HAZARDS/FAILURE MODES AND EFFECTS ANALYSIS MK 1 M00 0 L50-MUD C--ETC(U)

KTM-1327-01

NAEC-91-7958

(FAILURE MODES & EFFECTS ANALYSIS - SYSTEM) SAFETY ANALYSIS MKI MOD 0 LSO-HUD CONSOLF. SYSTEM

FIGURE 2. AUXILIARY ELECTRONICS BOX

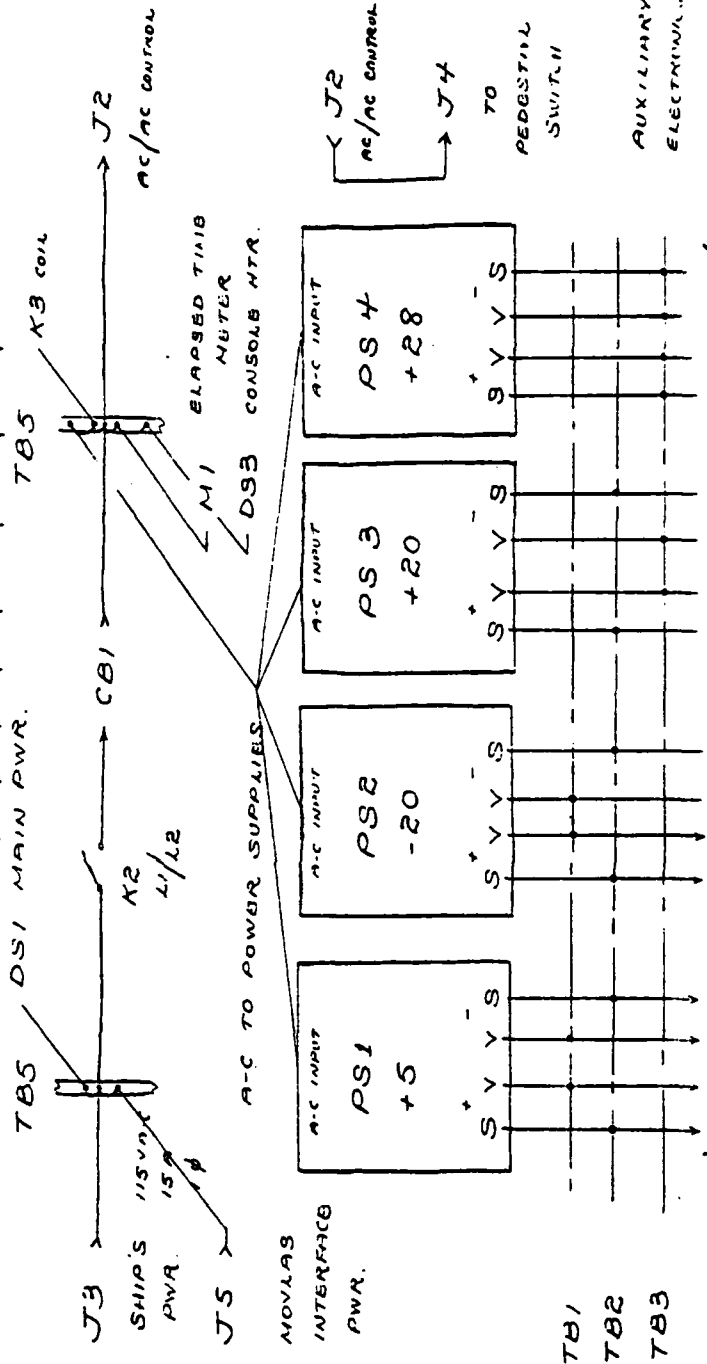
a) Loss of DC power supply output. 1) The loss of power supply outputs (PS1 thru PS4) which correlate with a lack of power supply A-C input power caused by a failure of one or several inter-linked time delayed components within Unit 2. The components are, in		-	x	-	-	-	x	x	II	C	The varied voltages provided by the auxiliary electronics assembly provide the energization of the instrumentation critical to the Landing Safety Officer's decision process. Failure of these supplies magnify the chance of information loss. The control of the entire LSO console hinges on the mechanical operation of a few mechanical relays and an airflow detector. Coupled with this eventuality is the possibility that an undetected and unprotected excursion of any power supply can cause a catastrophic chain of events to occur. To alleviate these problems, the

• RECOMMENDATIONS: (1) Provide a warning circuit within the LSO console (aural)

1.2.0 HYDRAULIC POWER PACKAGE (Unit 3A2) provides and distributes the hydraulic liquid pressure to cause its lift or retraction as needed. See the Schematic below and sketch at right.

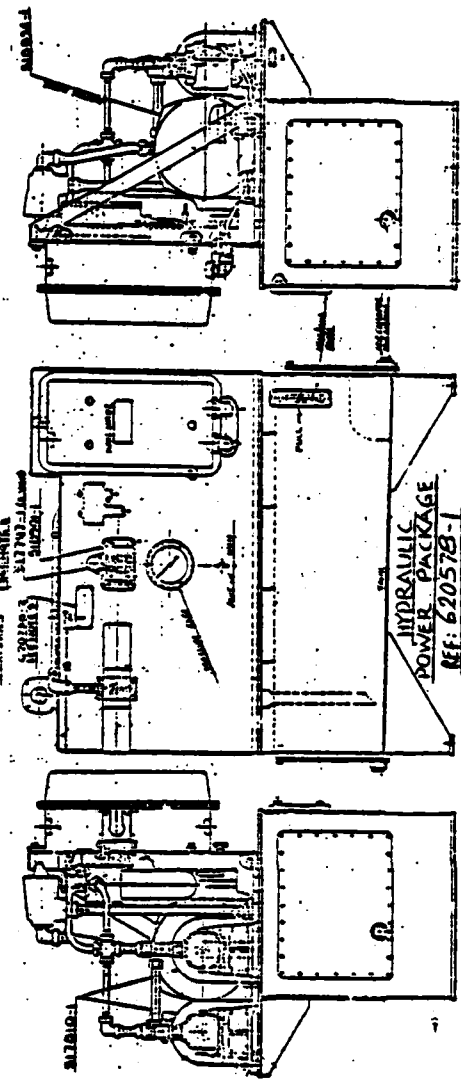
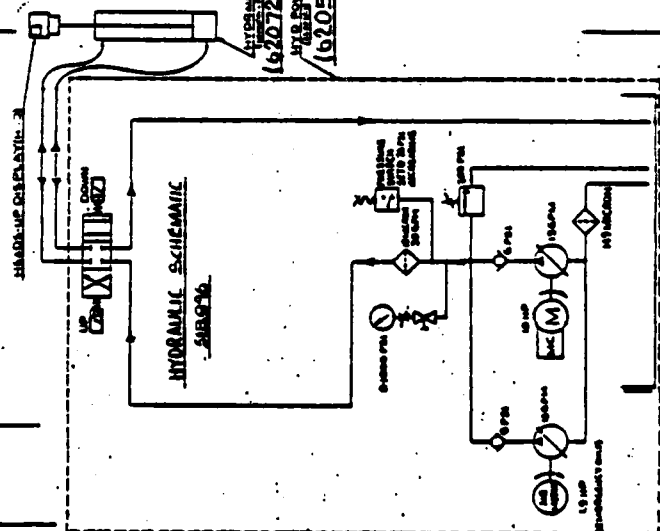
• RECOMMENDATION: Provide two gussets welded inside the Tank against the outside gussets 620579-11.

a) Mention in the Operation and Maintenance Manual the need to provide load to the Air Motor or otherwise limit its speed to 100 above that at maximum power.

b) Provide an overspeed governor or shut-off arrangement.
